SERVICE BULLETIN

Classification: AT95-004	Reference: NTB95-095	Date: October 4, 1995
-----------------------------	-------------------------	--------------------------

1995-1996 MAXIMA A/T KEY INTERLOCK CABLE

APPLIED VEHICLE(S): 1995-1996 Maxima (A32)
APPLIED VIN(S): All equipped with automatic transmission

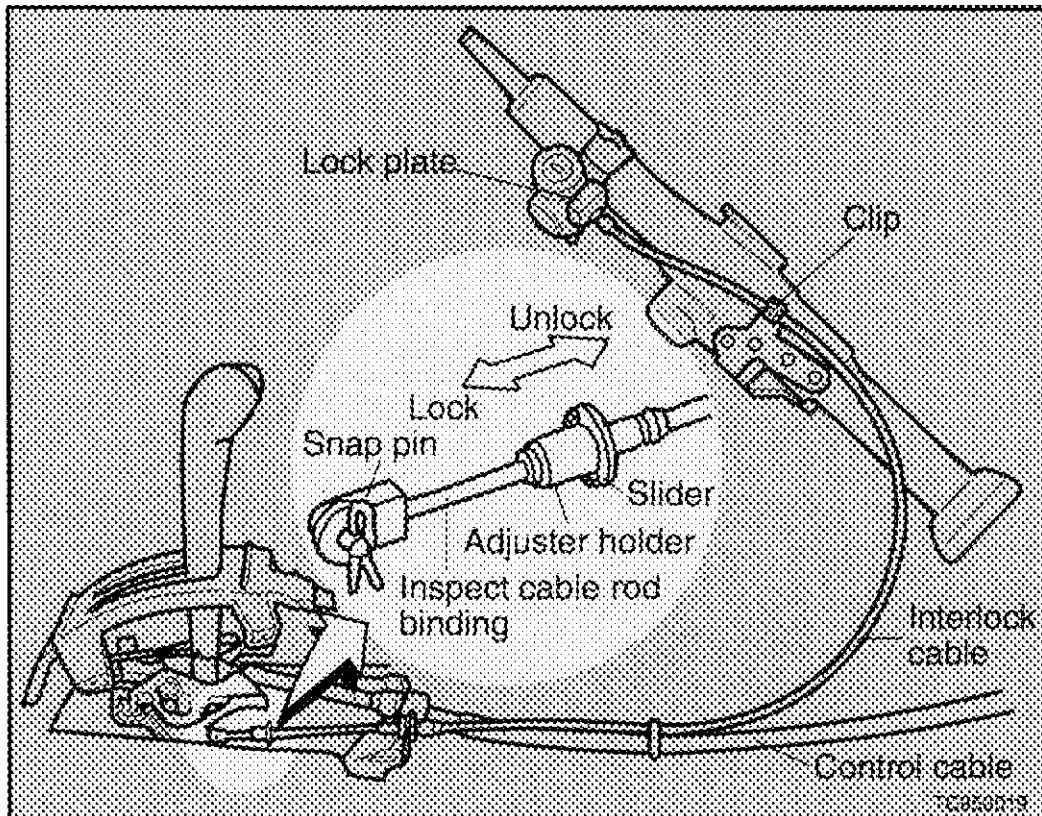
Customers may complain that the automatic transmission shift lever cannot be moved from Park under hot ambient conditions. The incident may occur more frequently when the vehicle is parked in direct sunlight. A new A/T interlock cable has been developed to reduce internal friction under hot ambient conditions.

Do not twist the adjuster holder when performing the cable adjustment. Twisting of the adjuster holder can increase internal friction of the cable and increase the risk of the shifter becoming stuck in park.

After cable replacement, ensure that the shifter **cannot** be moved after the key has been removed from the ignition. If the shifter can be moved without the key in the ignition, lengthen the cable adjustment and recheck.
